DAWSON STREET FLATS.

5203 37TH AVENUE SOUTH.

DESIGN STANDARDS.
EDG RESPONSES.

EDG RESPONSE ITEMS

CODE DEPARTURES.
UPPER LEVEL SETBACK.

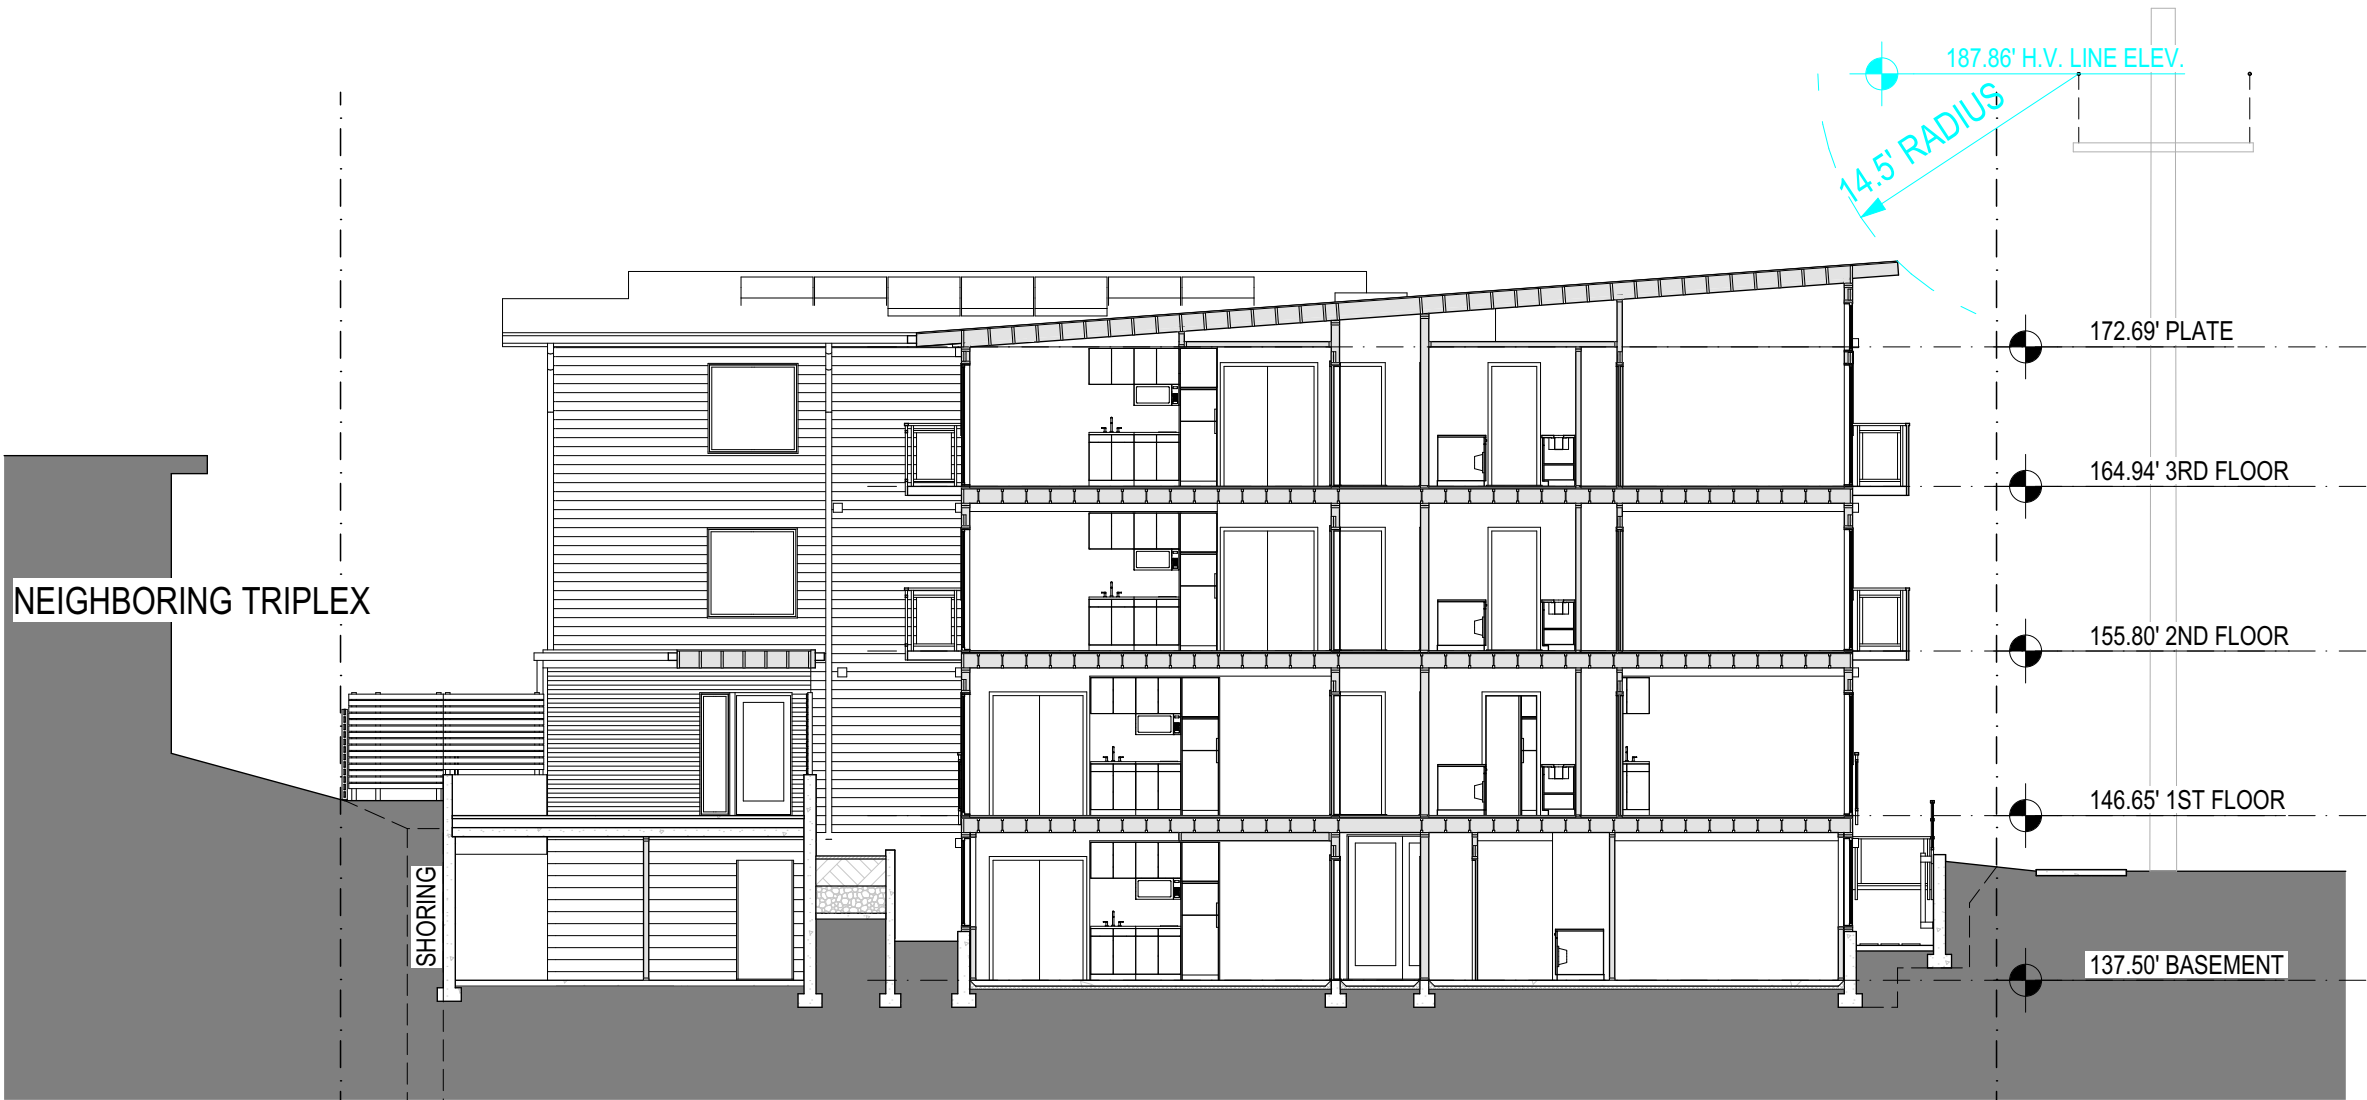
UPPER LEVEL SETBACK DEPARTURE REQUEST
23.45.518.L.1
Code text: *For structures with a 30 foot height limit according to Table A for 23.45.514, the upper-level setback requirement is 12 feet above a height of 34 feet.*

The land use-code requires that the upper level setback be applied to both street frontages (Dawson and 37th Ave frontages). The entire frontage of the north side of our proposed building (adjacent to Dawson Street) will comply with this upper level setback requirement. 60% of the east frontage of the building (adjacent to 37th Ave S) will comply with this requirement as well.

Departure request: We are requesting that the upper level setback be reduced from 12’ to 8’, along the east facing facade fronting on 37th Ave S.

CS2.C.1: Relationship to block, Corner Sites: Additional vertical elements adjacent to this corner site would enhance the transition from the single family to the multifamily zones. Presenting a low profile on the south side of the site helps to soften the impact of our building on the single-family neighbor to the south. Presenting a higher profile closer to Dawson helps reinforce that this is a multi-unit structure and is a transition point between zones.

CS2.A.2: Architectural Presence: While this is not a “high profile” building site, this building will have an important role in helping to reinforce the development patterns that are taking place in Columbia City. Reduction of the upper level setback requirement will allow us to help “contribute to a strong street edge” at this location, enhancing the public realm.

CS2.B.1: Site Characteristics: 37th Ave presents a unique condition in that there is a lot of distance between the property line and the street (at least 32’). Having a bit more vertical mass adjacent to this wide sidewalk/planting strip area is a completely appropriate response to this unusual condition.

DC2.B.1: Façade Composition. We feel that it is important to break the street facing facades into smaller blocks in order to help create elements that are more in scale with the surrounding single family dwellings. Part of our massing concept is to create vaulted rooflines in discreet portions of the facade in order to provide roofline variation. Vertical variation helps to reinforce these massing blocks of the building, and provides a more animated building façade. This departure would allow us to establish the visual rhythm that works well at this site, allowing us to “consider the composition and architectural expression of the building as a whole.”
